# Access Compliance Report

## Public Rights-of-Way

### (Curb Ramps)

Intersection ID: 9633	Main Street: CRESWELL_CT	Cross Street: STONE_ABBEY_PL	Location: E
ADA ID: 73133EB108BE	Ramp Type: Perp	Initial Pass/Fail: Pass	Overall Compliance: No
Severity Score: 5			
Codes/Mitigation Info/Possible Solution		Field Measurements/Component Compliance

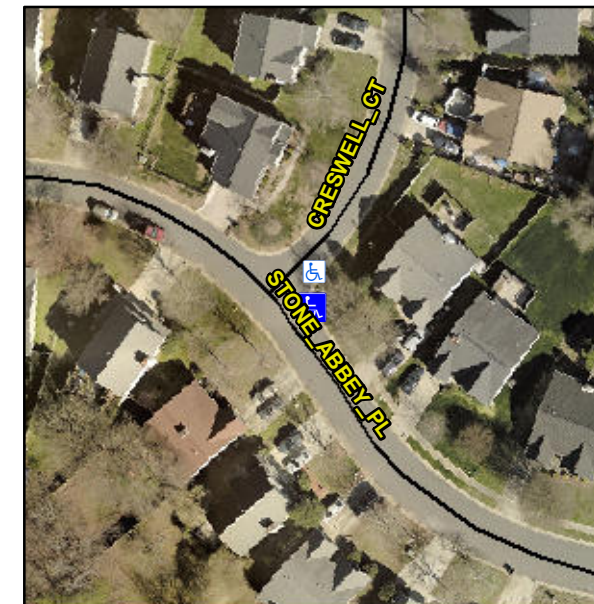
**Not Found, R304.2.2-Perp, R304.3.2-  
Para, R305.2, R304.5.4**

Compliance	Description	Data	Compliance	Description	Data
N/A	Ramp Length (in)	49.0	Yes	Ramp Slope (%)	7.3
Yes	Ramp Width (in)	48.0	Yes	Ramp XSlope (%)	0.4
N/A	Flare Type LT	Sloped	N/A	Flare Type RT	N/A
N/A	Flare Slope LT (%)	5.1	N/A	Flare Slope RT (%)	2.7
N/A	Flare Traversable LT?	No	N/A	Flare Traversable RT?	No
Yes	Landing Length (in)	51.0	Yes	DWS Provided?	Yes
Yes	Landing Width (in)	48.0	Yes	DWS Contrast?	Yes
No	Landing Slope (%)	2.6	Yes	DWS Length (in)	24.0
Yes	Landing X Slope (%)	0.0	Yes	DWS Full Width?	Yes
N/A	Landing Curb? (Y/N)	No	No	DWS Offset (in)	7.5
N/A	Shared Landing?	No			
Yes	Gutter Ponding?	No	No	Gutter Slope (%)	6.2
Yes	Gutter Lip Ht (in)	0.0	Yes	Gutter X Slope (%)	0.8
N/A	Painted X Walk1?	No	N/A	Painted X Walk2?	N/A
	X Walk 1 Direction	To SW		X Walk 2 Direction	N/A
N/A	X Walk 1 Width (in)	N/A	N/A	X Walk 2 Width (in)	N/A
	X Walk 1 Slope (%)	4.7		X Walk 2 Slope (%)	N/A
	X Walk 1 X Slope (%)	2.3		X Walk 2 X Slope (%)	N/A

**Remove & Replace Entire Ramp.  
Remove & Replace Gutter.**
